RIVERVIEW OAKS SUBDIVISION, UNIT 2 & UNIT 3

APPLICATION NUMBER 12 DATE July 20, 2006

REQUEST Subdivision

RIVERVIEW OAKS SUBDIVISION UNIT 2

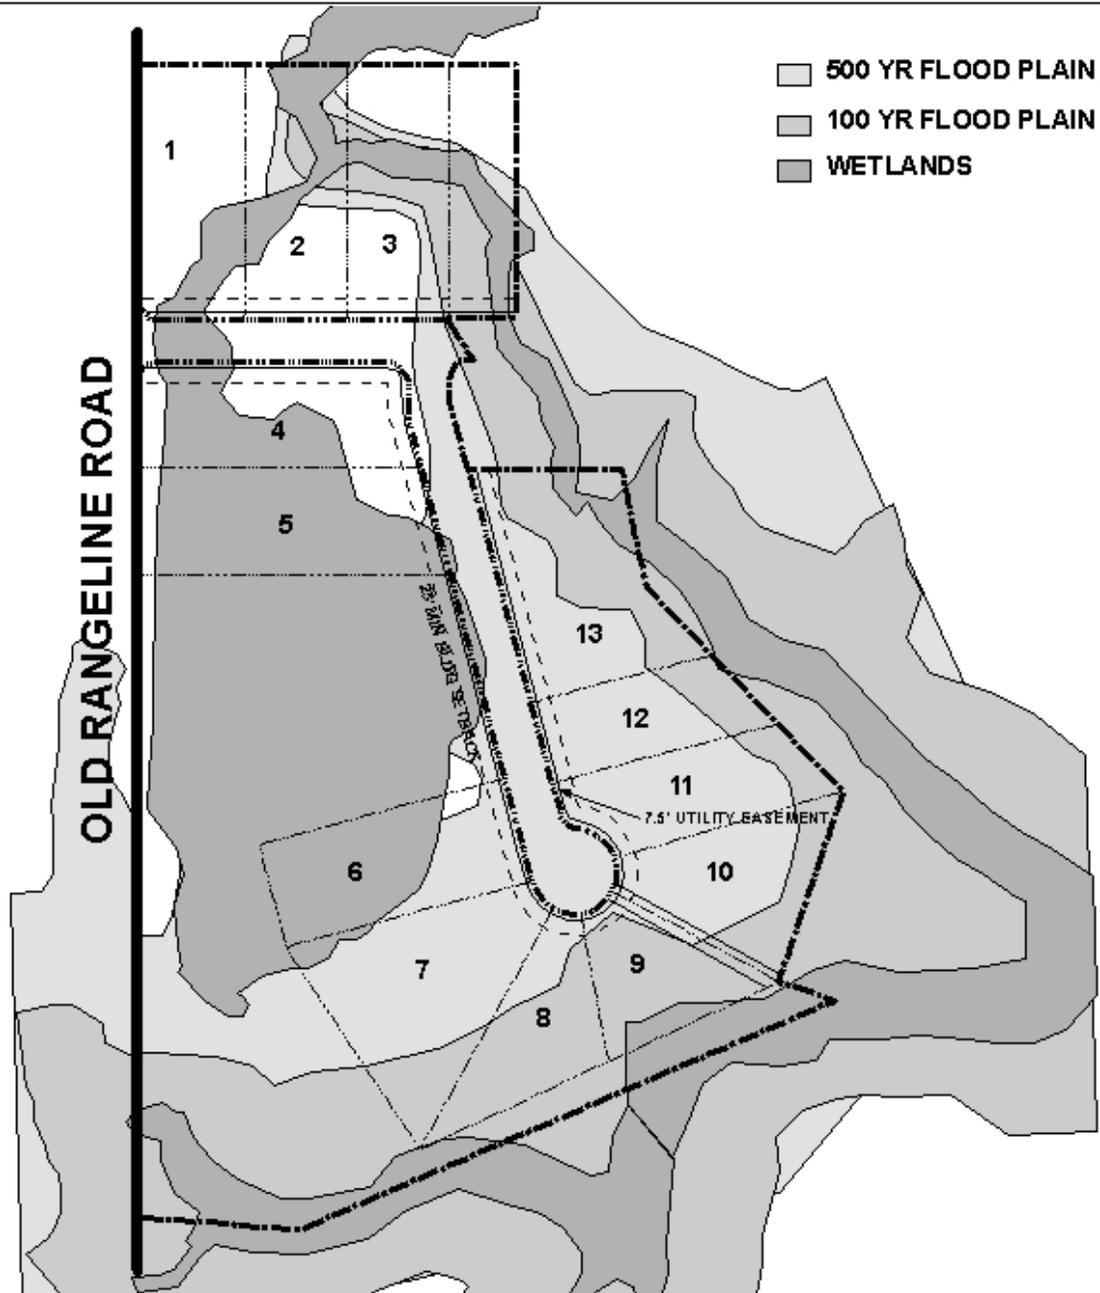
The site fronts Old Rangeline Road, a minor street which has a right-of-way width of 60 feet. While Old Rangeline Road is a minor street, access management is a concern. Proposed lots 1, 4 and 5 of Unit Two have frontage onto Old Rangeline Road as well as the street that will be developed as part of the subdivision. A note should be placed on the final plat, if approved, denying direct access to Old Rangeline Road for lots 1, 4, 5, and any common areas abutting Old Rangeline Road.

The 25-foot minimum building setback line is not depicted for the lots or common areas fronting onto Old Rangeline Road, however, it will be required on the final plat, if approved.

The plat is recommended for Tentative Approval subject to the following conditions: 1) placement of a note on the final plat stating that lots 1, 4, 5 and common areas are denied direct access to Old Rangeline Road; 2) verification by the applicant that all lots provide a minimum buildable area of 7,200 square feet, exclusive of wetlands and floodways; 3) labeling of all common areas and detention common areas as such, and placement of a note on the final plat stating that common areas and detention common areas are to be maintained by the property owners association; 4) depiction of the 25-foot minimum building setback line along Old Rangeline Road; 5) correction of the written legal description; 6) approval of all applicable federal, state and local agencies regarding the wetlands and floodplain issues prior to the issuance of any permits or land disturbance activities; and 7) placement of a note on the Final Plat stating that any lots which are developed commercially and adjoin residentially developed property shall provide a buffer in compliance with Section V.A.7. of the Subdivision Regulations.

RIVERVIEW OAKS SUBDIVISION, UNIT 3

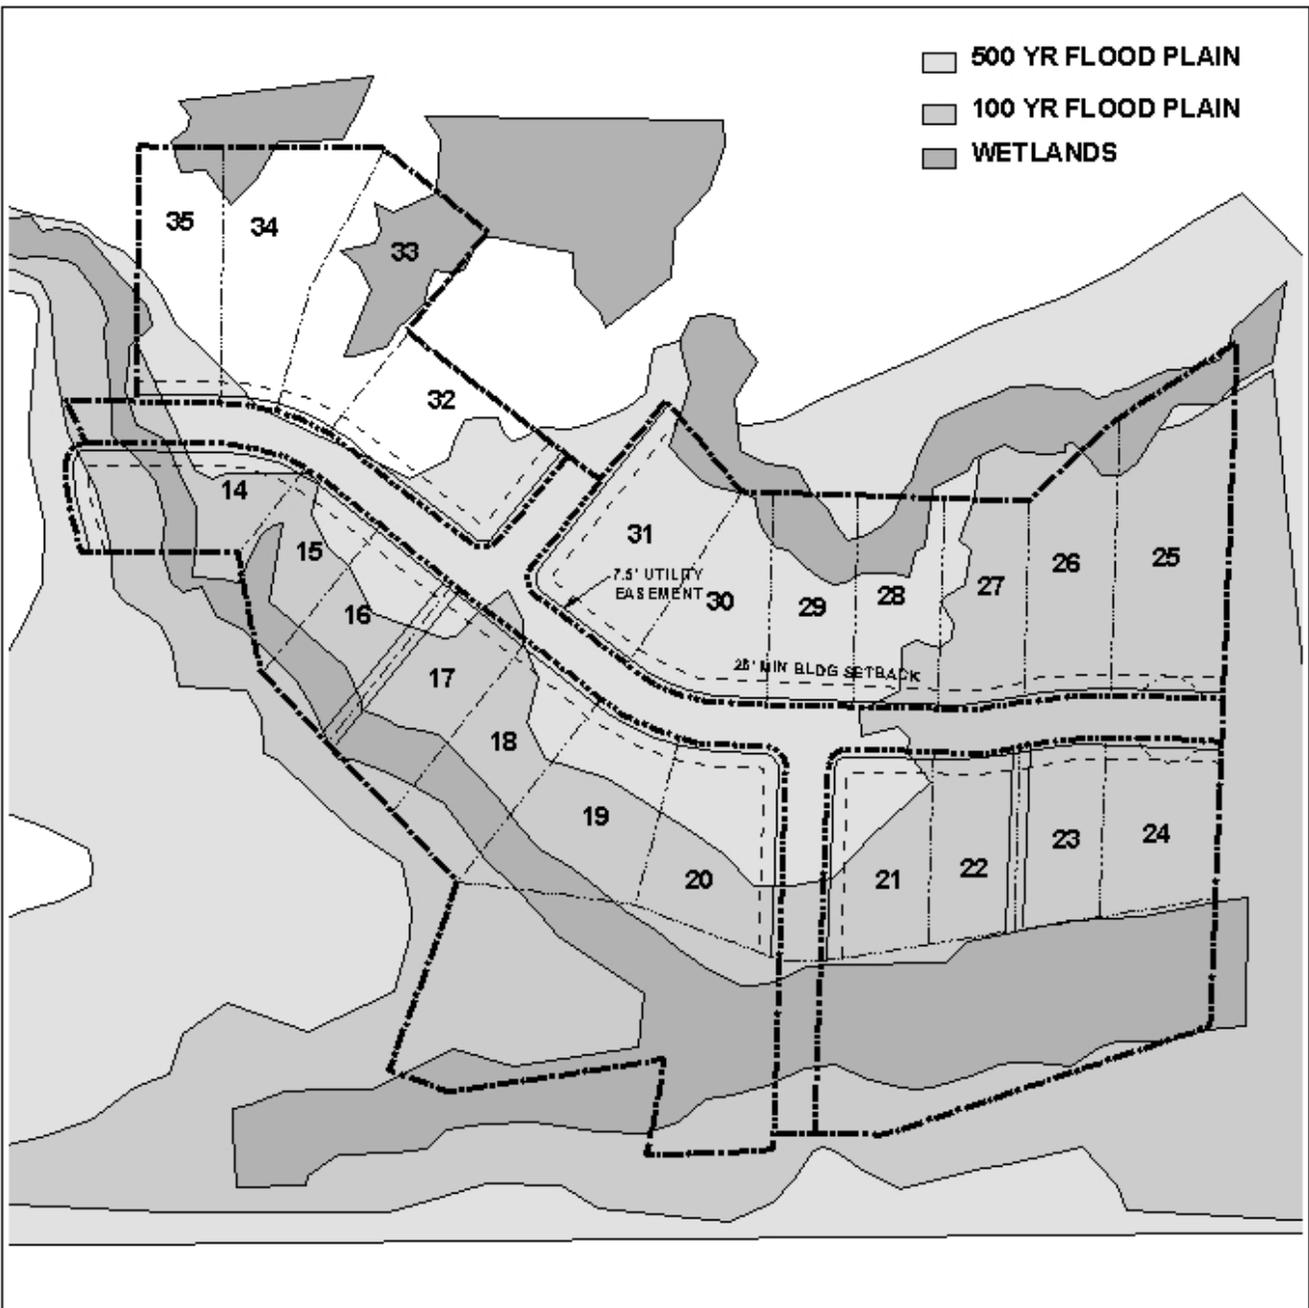
The written legal description for Units Two and Three has an error where it describes the bearings and distances adjacent to proposed lots 32 and 33. The written legal description should be corrected before recording of the final plat.
